Reviewers' comments (Oct. 11th, 2017)

Reviewer #1: Dear Author, please find here a list of comments from my side.

Figure 1: The number of active pads versus the measured momentum of the elastic ^4He tracks.

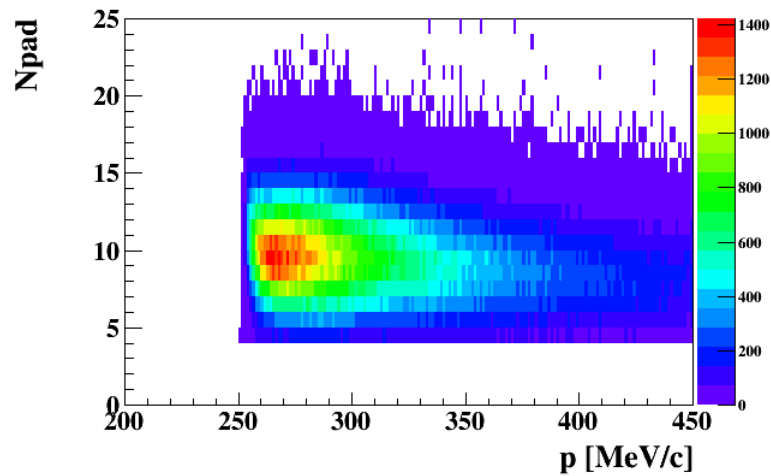
16. Figure 11: I don't understand it. How many tracks does the histo contain? If the single pad has 128 channels, how many channels does the single bin contain? Moreover, is the dE calculated on pad by pad basis? In that case, why don't you put just one point in the histo for each pad? What is the mean number of channels or pads fired by one track? Sorry for the list of questions, but I could not understand the figure.

- It is for only one track (written in the caption). - We don't understand your second question. A pad is a channel. Do you mean how many pads are fired for a single track? Figure ?? shows the number of active pads as a function of the momentum for the collected elastic ^4He tracks.

- dE is calculated from the ADCs of the individual pads that read out hits corresponding to the same track. One needed to know the individual step size very precisely to put dEdx from the individual pads, which is not available. - Last question is addressed by figure ??.

The mean value is around 10 pads.

Figure 2: the number of hits distribution for the collected elastic ^4He tracks from the 1.2 GeV dataset.

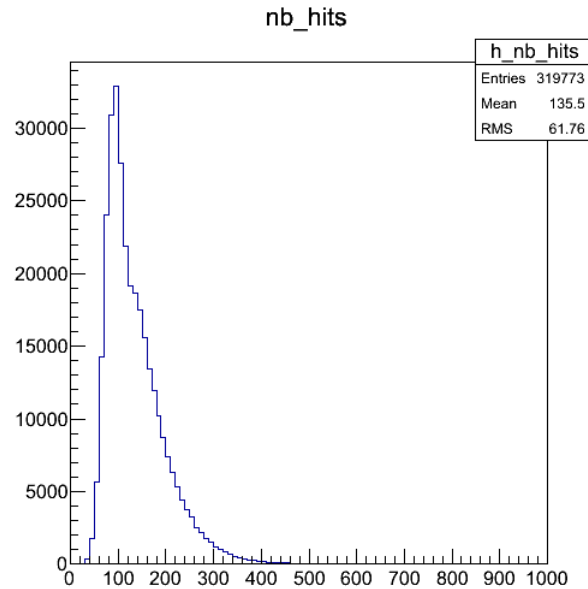
20. How was the "10 hits" cut chosen? What is the mean number of primary ionization in this gas mixture?
Figure 2 shows the number of hits distribution for the collected elastic ^4He tracks from the 1.2 GeV dataset. The mean number of hits is around 135 and the 10 hits cut at the reconstruction level is a loose cut to reduce the level of the spurious tracks.
